JP-4 SERVICE NOTES

Second Edition

INFORMATION ON DESIGN CHANGES

JP-4

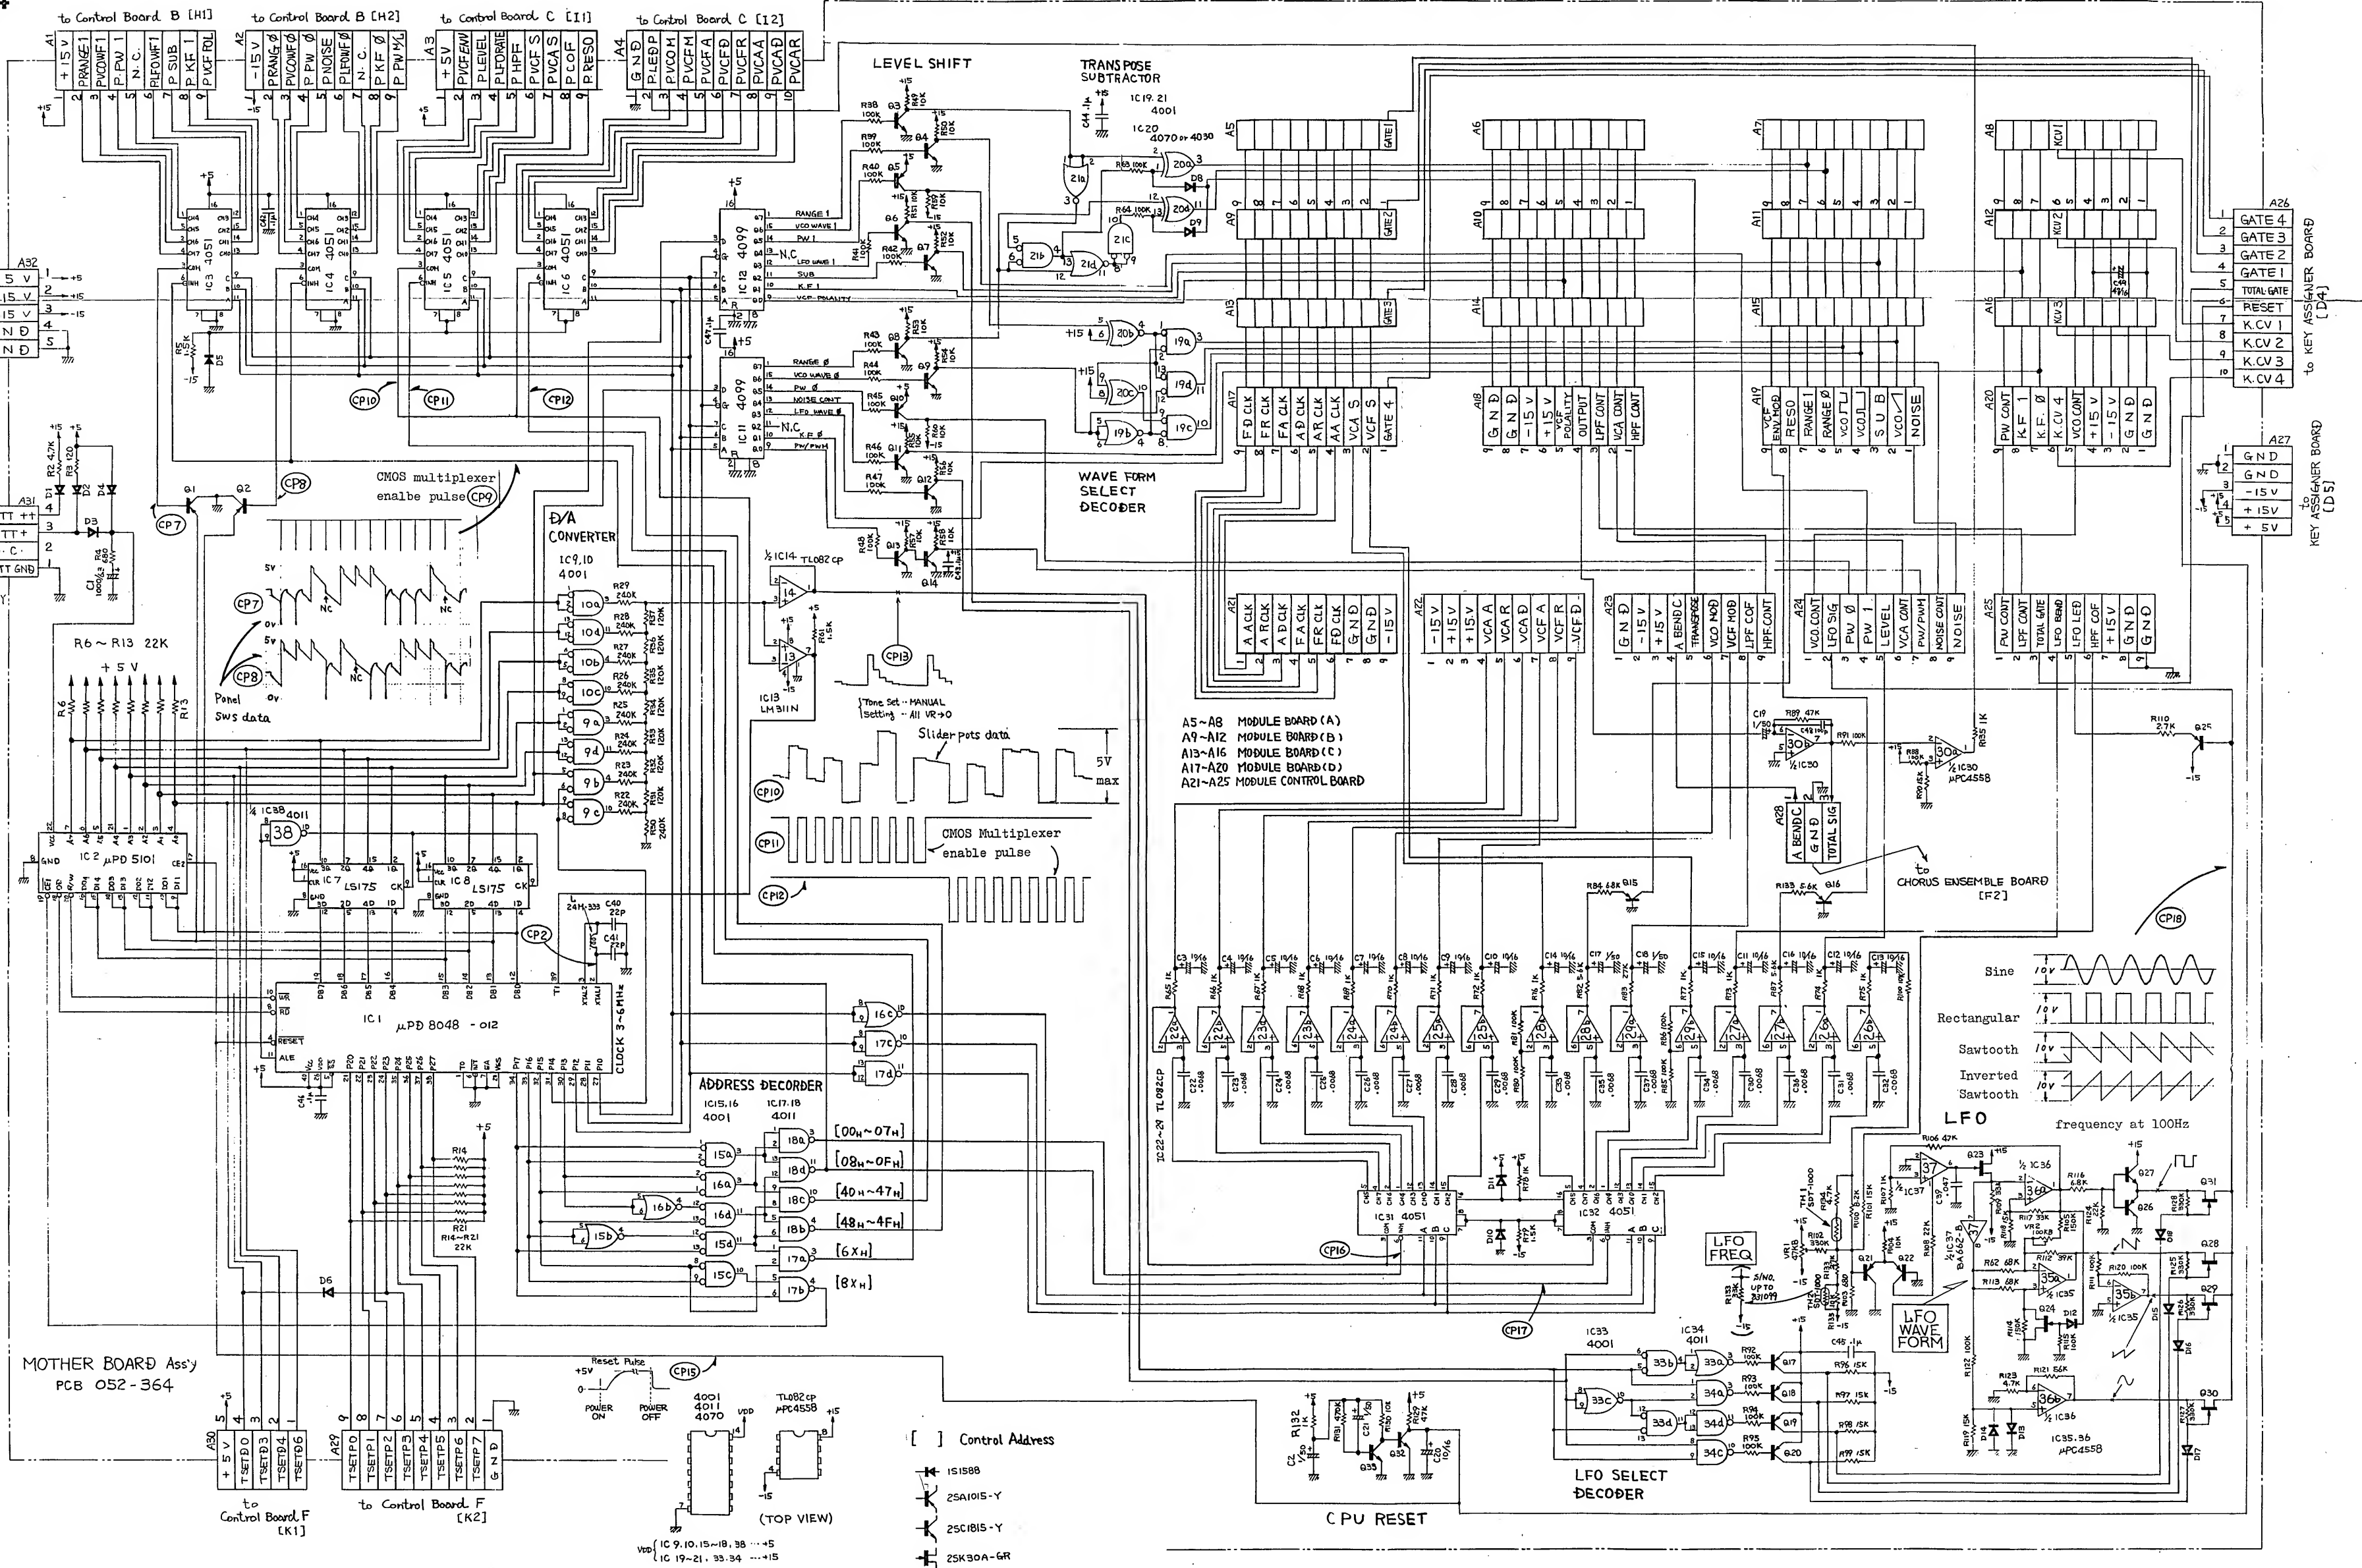
Protecting IC20
against break-
down
With S/N 891900
(181-019B)

Preventing IC13 and
IC14 from misreading
D/A outputs
With S/N xx3800
(181-019 C/D)

Primary Circuit Change
Circuits in dash circles concern VCF
control system.
The modifications show constant voltage
application for use together with Module
board 181-020 -D, -E or -F, while orig-
inal ones for 181-020 -A, -B or -C.
(Refer to pp. 12 and 19.)

MODIFICATIONS ON MOTHER BOARD
other than those described on the left

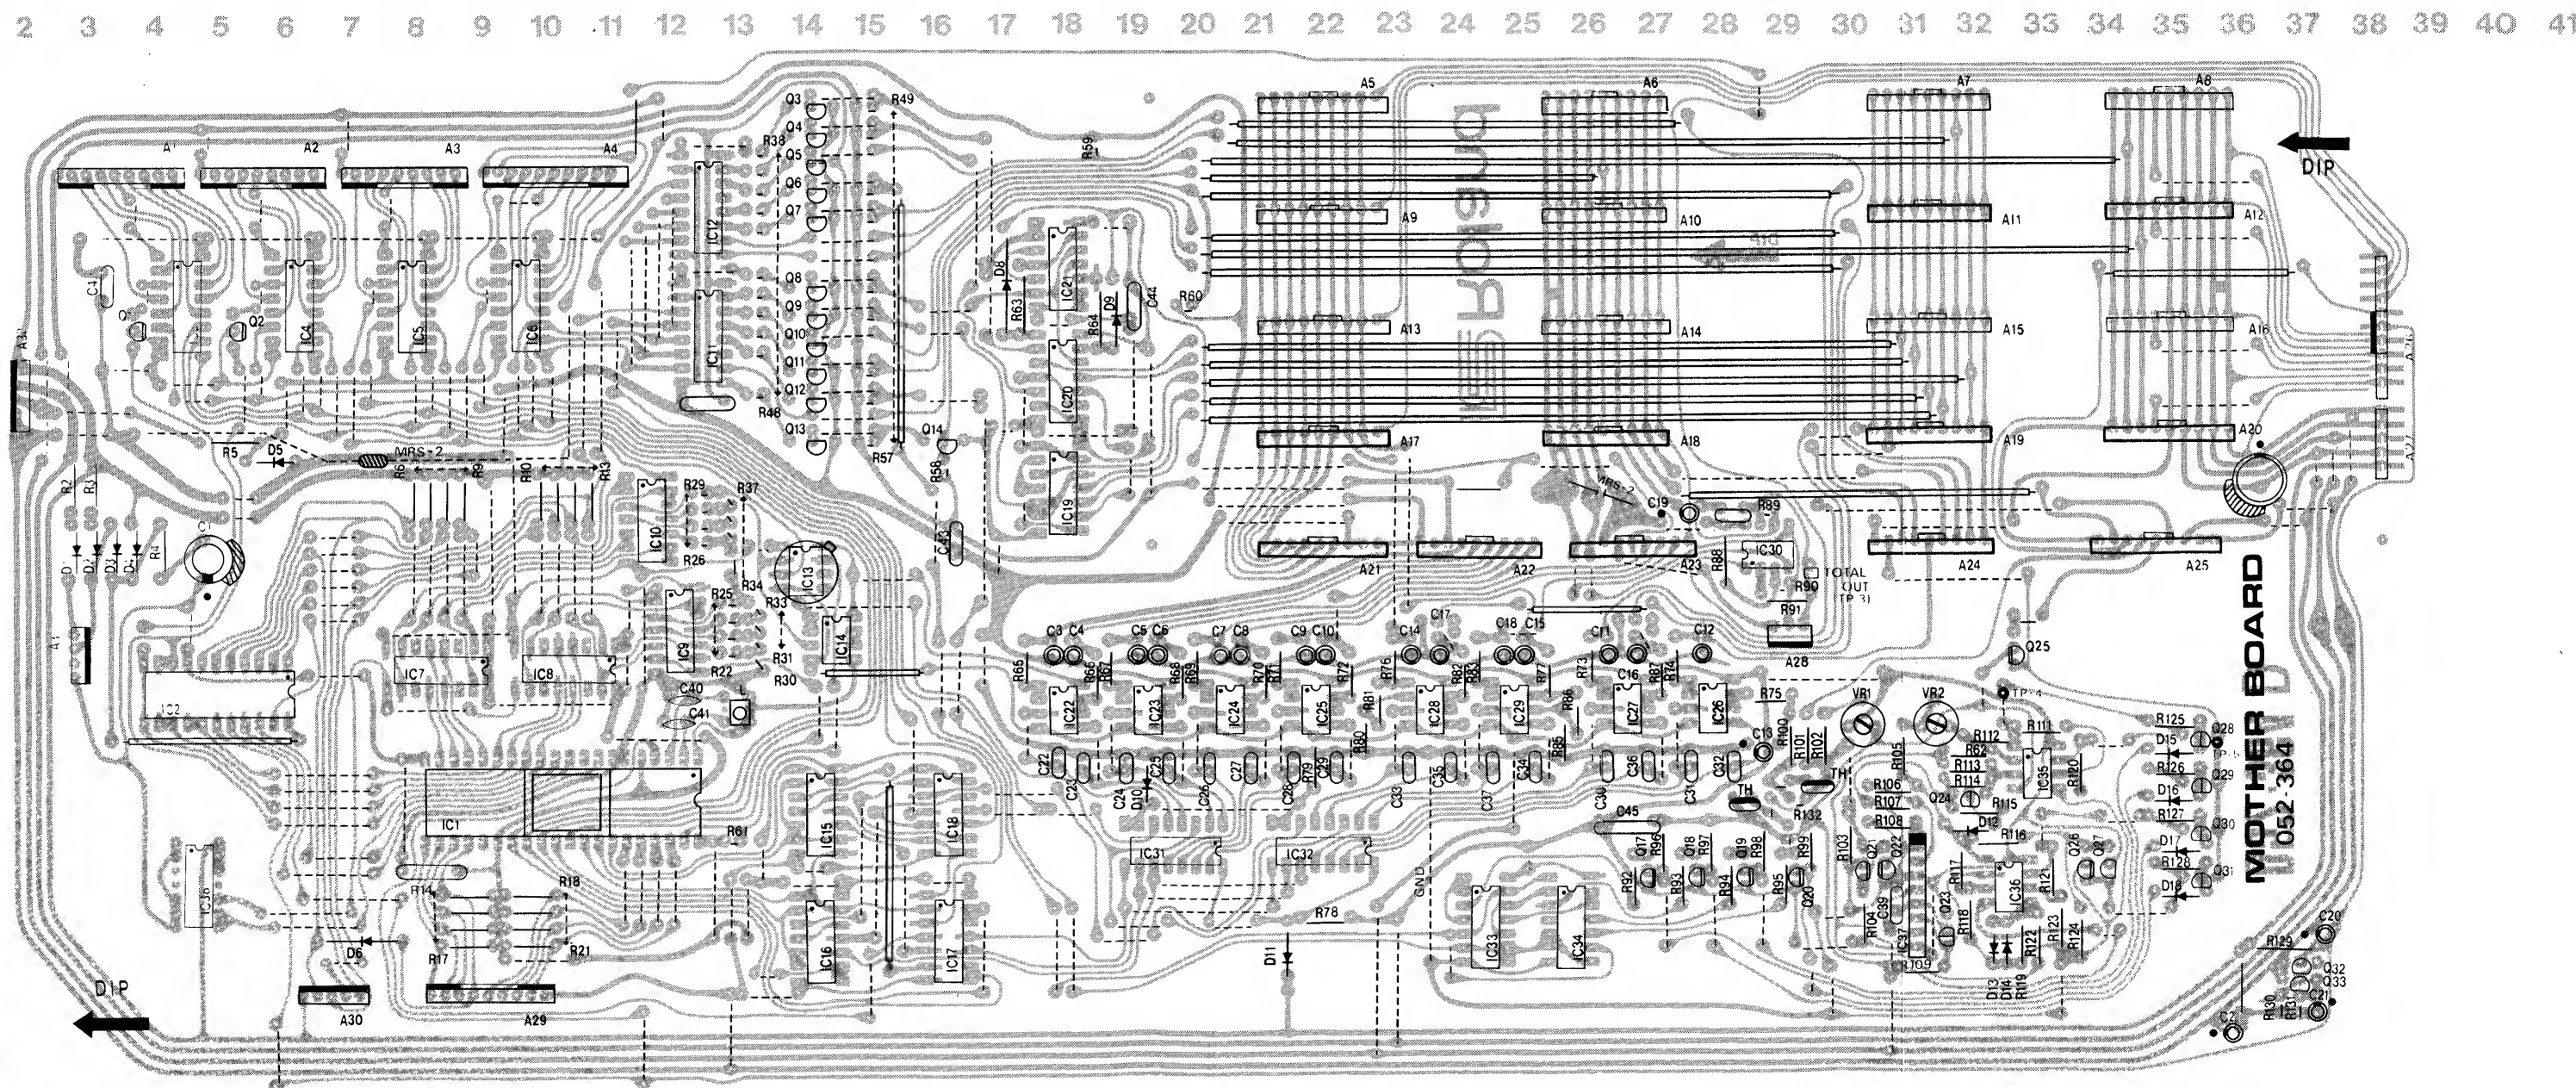
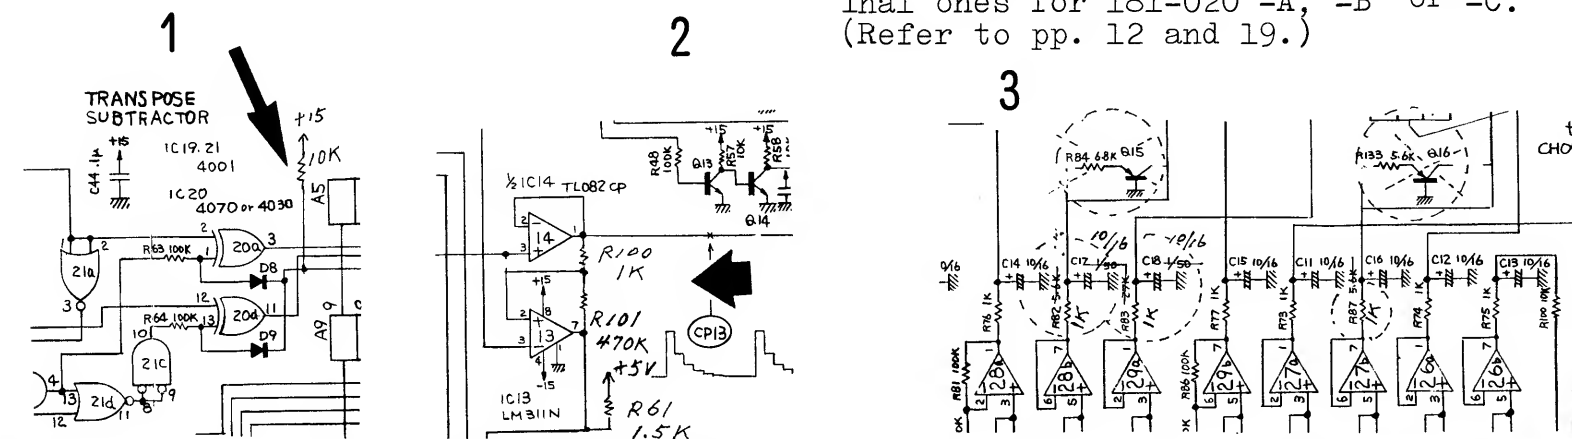
4. Disconnecting ground path from Control Boards A,B and C
The jumper wire leading to pin 1 of terminal A4 is removed
to prevent noises from being induced on control boards.
With Serial Number 820959. Refer to illustration on back
page.

5. Direct wiring to avoid loose connections

For stable VCO performance, lead wires (-15V and ground)
from power supply board 181-024 are directly soldered at
terminal A27.

With Serial Number 871600. See pp. 16-2, 26-1.

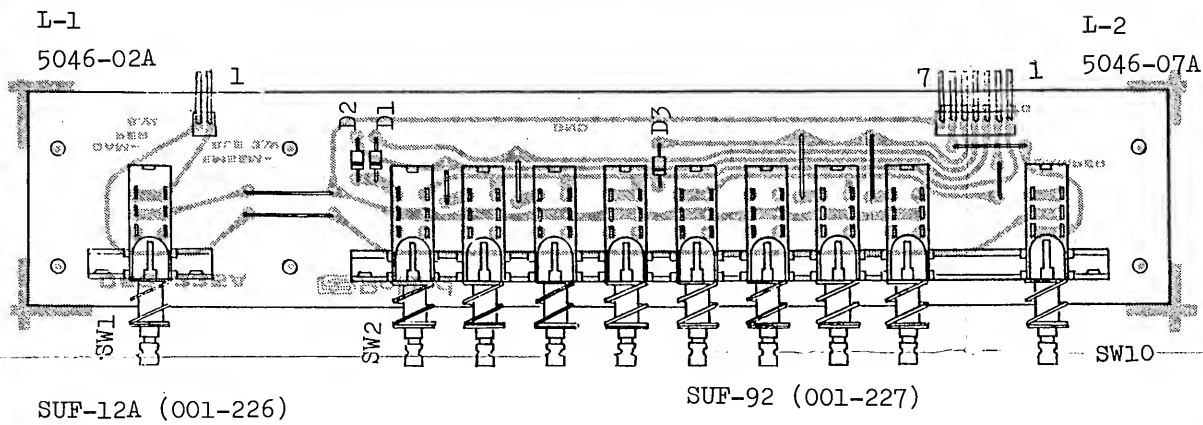
To compensate for loose connection in A27, pins 1 and 2... GND pin 3... -15V are directly connected to Power Supply Board via exclusive wires - both at the foil side. SEE pp. 12-1(5), 26-1.

IC3 IC6 Designation

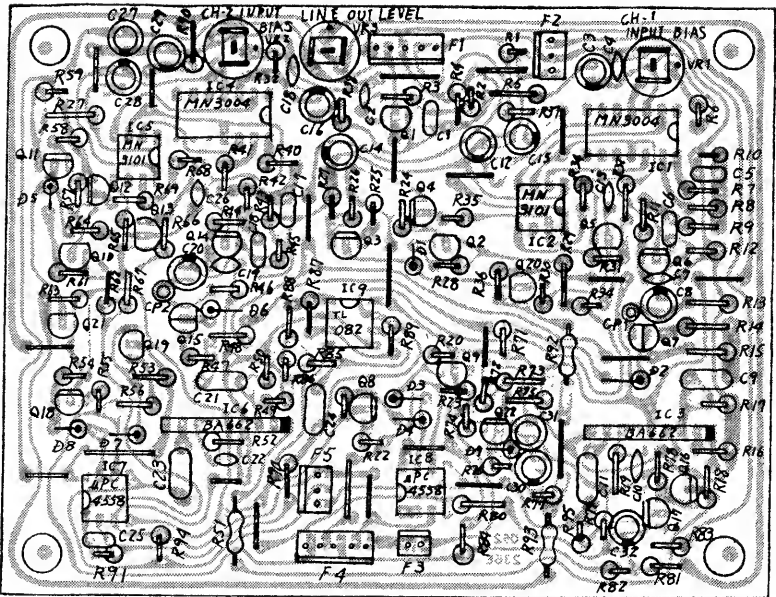
MSM4069RS is dominant because of its greater S/N ratio, but its threshold varies from IC to IC within slightly larger range when compared with other brands. These variations in threshold are compensated for by changing the value of R52 and R53 from 330k to 390k ohms.
